APPLICATION NO.	FILING DATE	FIRST NAMED INVENTOR	ATTORNEY DOCKET NO.	CONFIRMATION NO.
10/657,627	09/08/2003	Joon Keun Lee	434/1/004	1539

Office Action Summary	Application No. 10/657,627	Applicant(s) LEE ET AL.	
	Examiner John Hoffmann	Art Unit 1731

page 5A

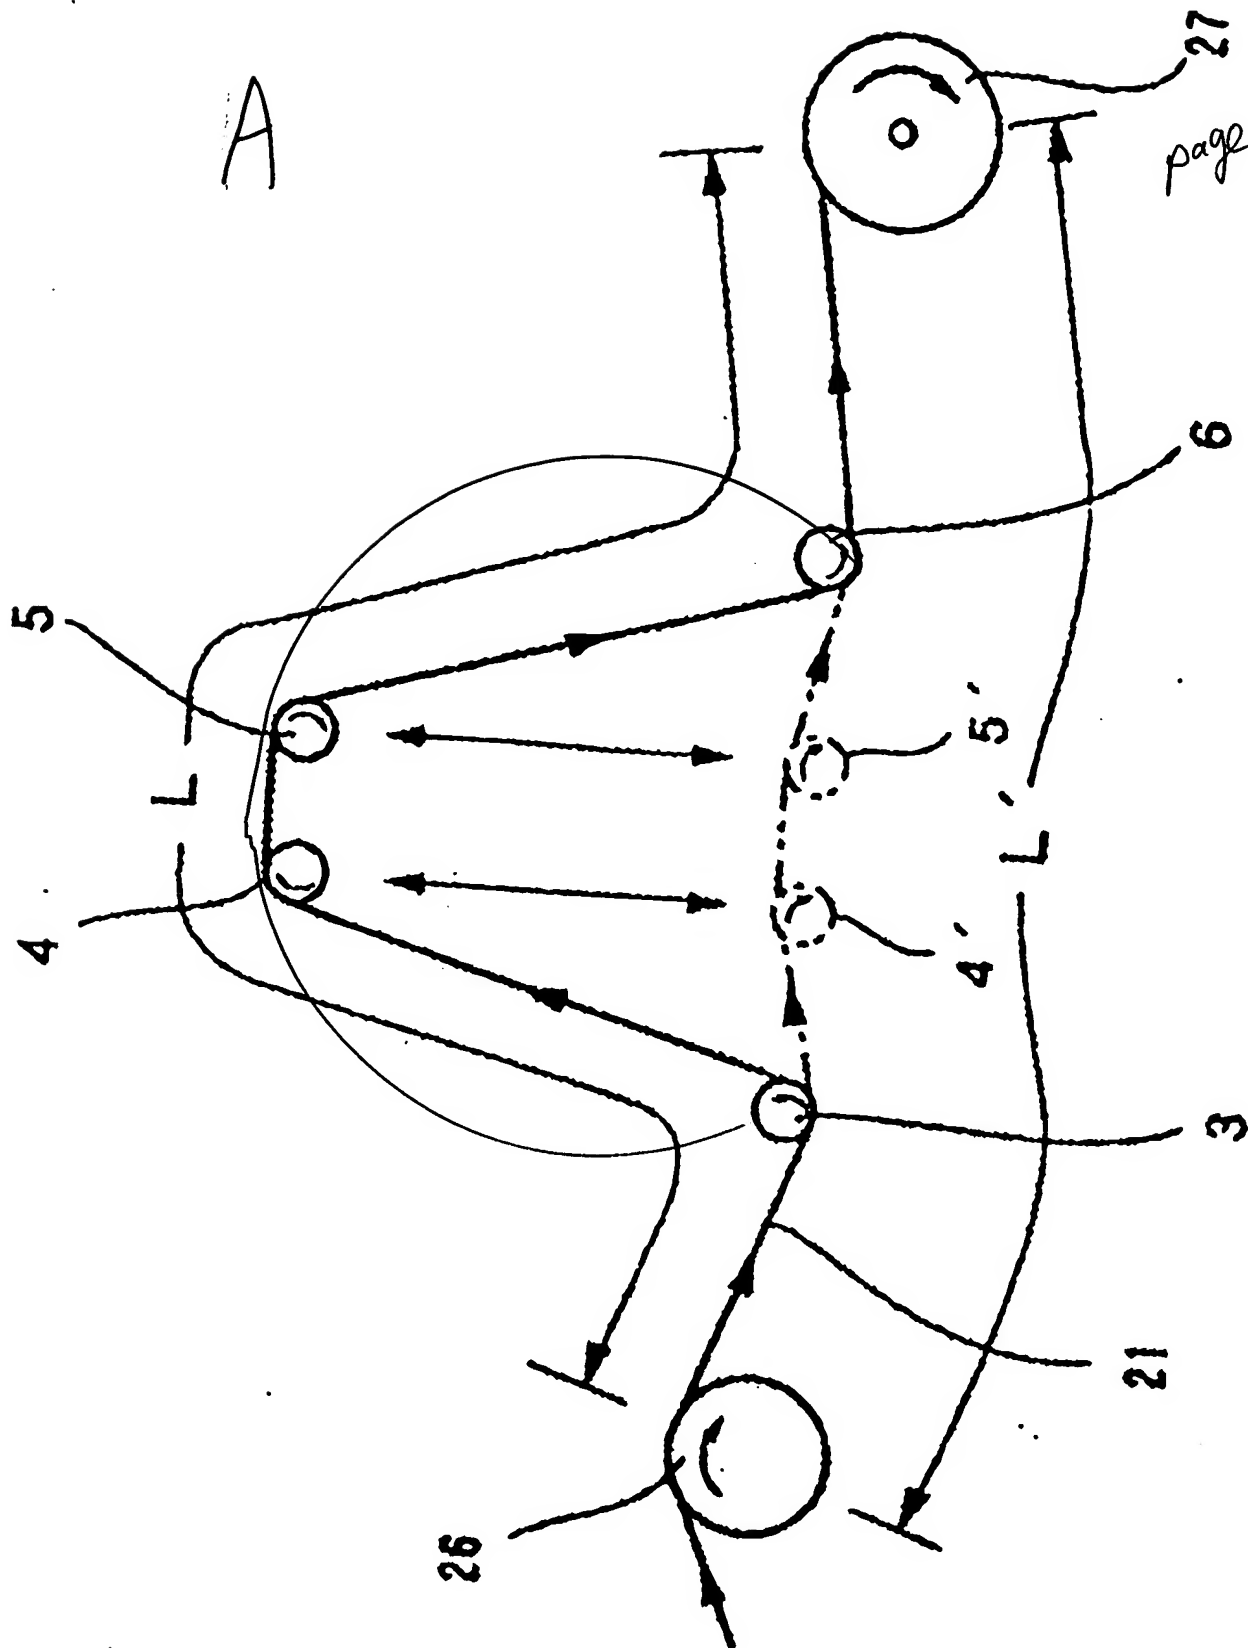
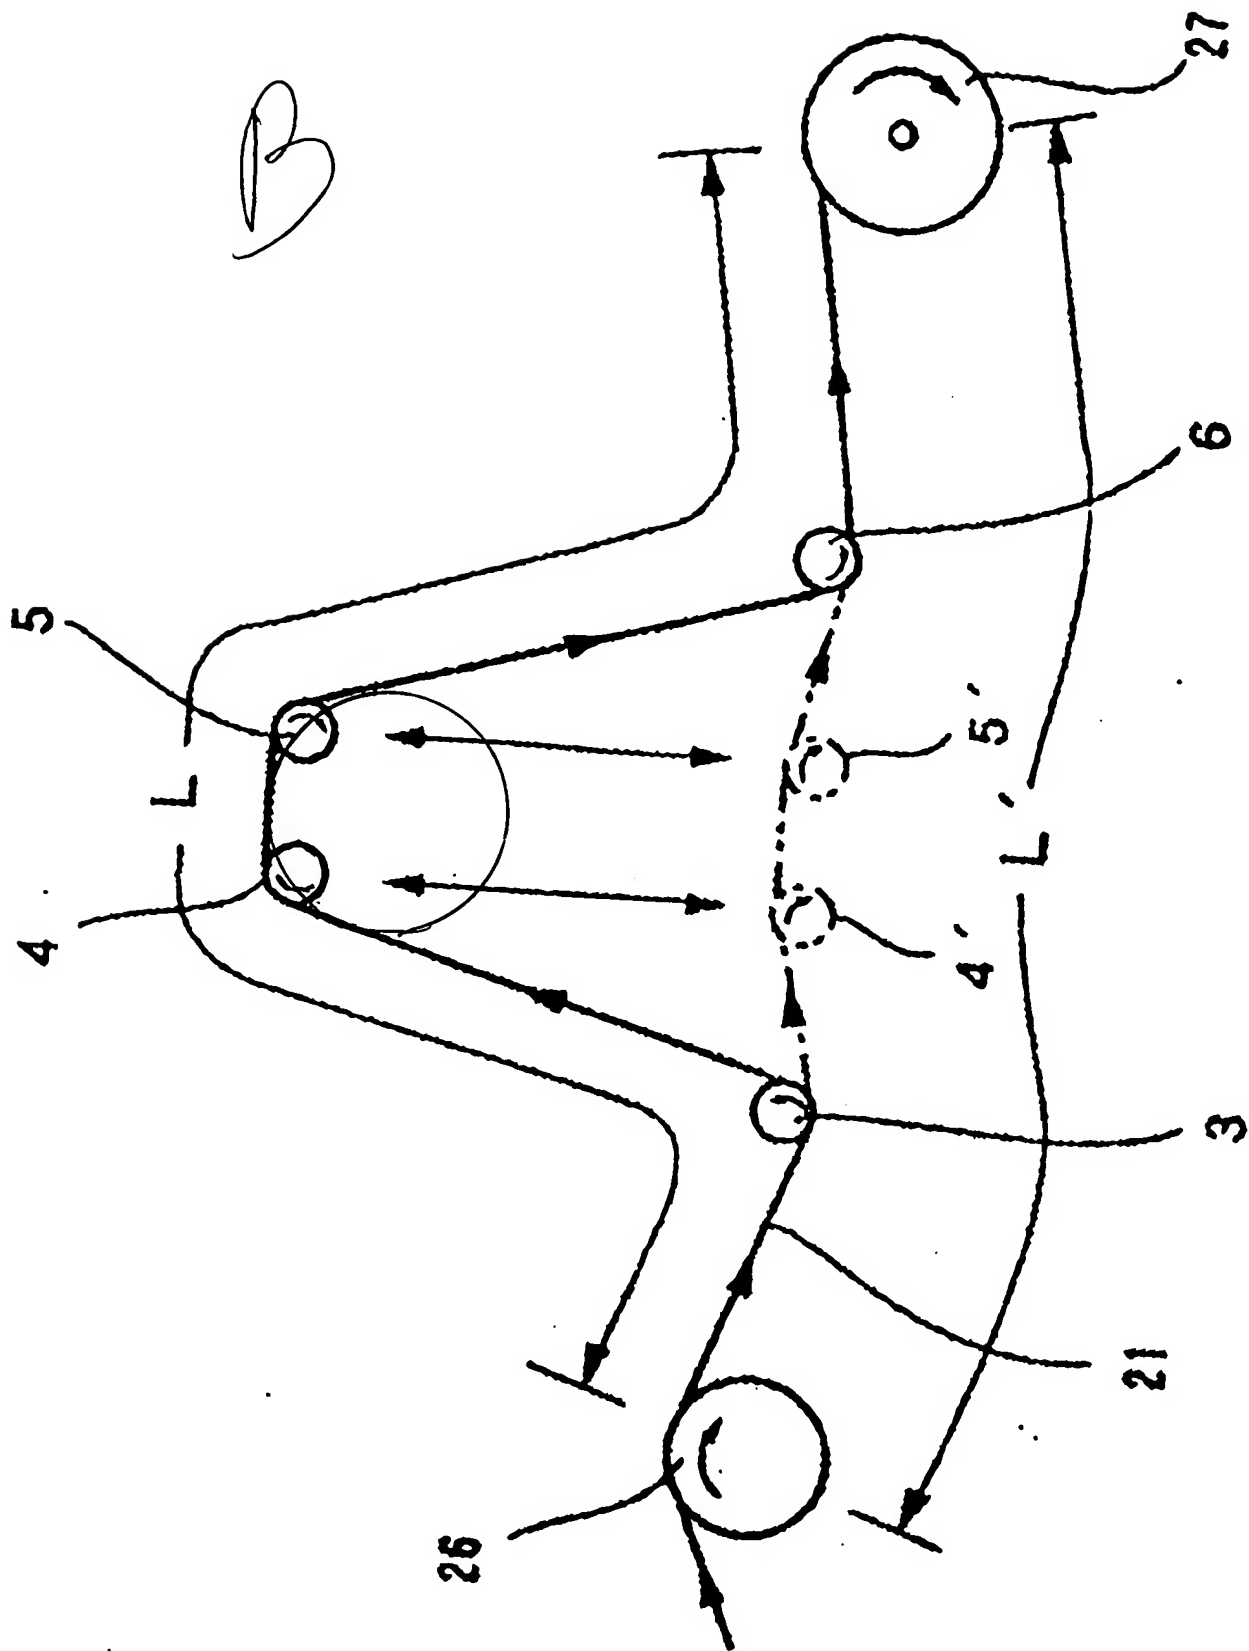
Looking to the Yoshida drawings: 12 is the heating furnace; 22, 25 are fixing rollers; Col. 1, lines 40-45 discloses the fiber standard value controller unit; 4, 5 and/or 23 are the moving rollers (col. 6, lines 33-41); and 27 is the winding reel. See also the Office action of 6/28/2005 for more details.

As to the curvature radius and adjustment, it is deemed that such is inherently met. Alternatively, it is an intended use limitation – which Yoshida is capable of achieving.

A recitation of the intended use of the claimed invention must result in a structural difference between the claimed invention and the prior art in order to patentably distinguish the claimed invention from the prior art. If the prior art structure is capable of performing the intended use, then it meets the claim. In a claim drawn to a process of making, the intended use must result in a manipulative difference as compared to the prior art. See *In re Casey*, 152 USPQ 235 (CCPA 1967) and *In re Otto*, 136 USPQ 458, 459 (CCPA 1963). It is noted that even with Applicant's invention, if one were to apply a higher tension to the fiber as shown in figure 5, the fiber would not droop in the interval between rollers 18 and 19. Similarly, if one were to use lower tension in the Yoshida invention, the Yoshida fiber would droop and take a radius. The rollers are on the same side (the under side) of the fiber.

As to the release bending stress – it is clear that the bending stress changes to zero after it passes around a roller. In other words, there is a bending stress when the

fiber is bent, and there is no bending stress when the fiber is not bent. The same applies to the concentration.
